Technical Service Bulletin

Mazda North American Operations
Irvine, CA 92618-2922

| Subject: KNOCKING NOISE FROM STEERING COLUMN WHILE DRIVING | Bulletin No.: 06-001/22 |

Modified part (Service part of Steering Column):

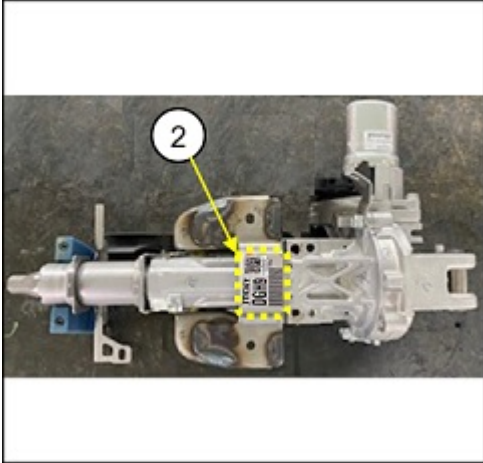
NOTE: The part number of the steering column has not been changed for the modification. Identify modified steering columns by the lot number on the steering column as follows.

- Lot Number (1) **11040001** or later.

The location of the lot number label (2) is the upper side of the steering column.

Replacement Parts Location:

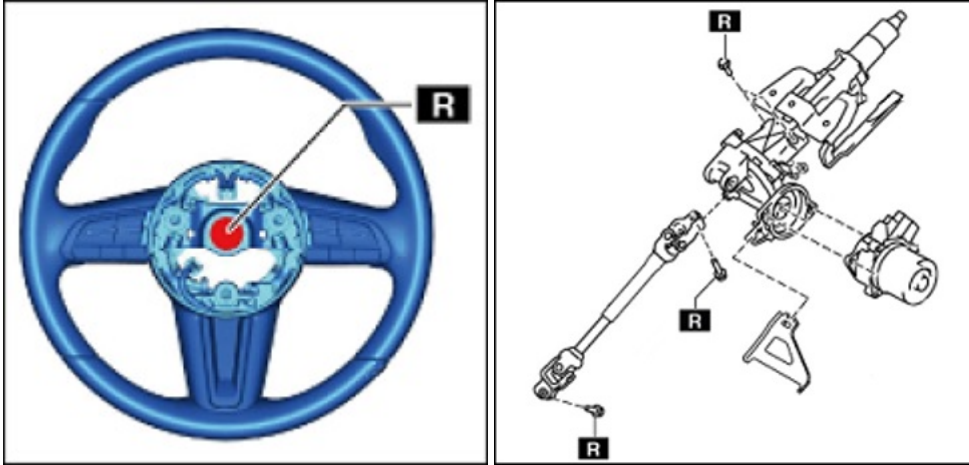
- Lockbolt for Steering wheel
- Joint bolts for Intermediate shaft
- Bolts for Protector
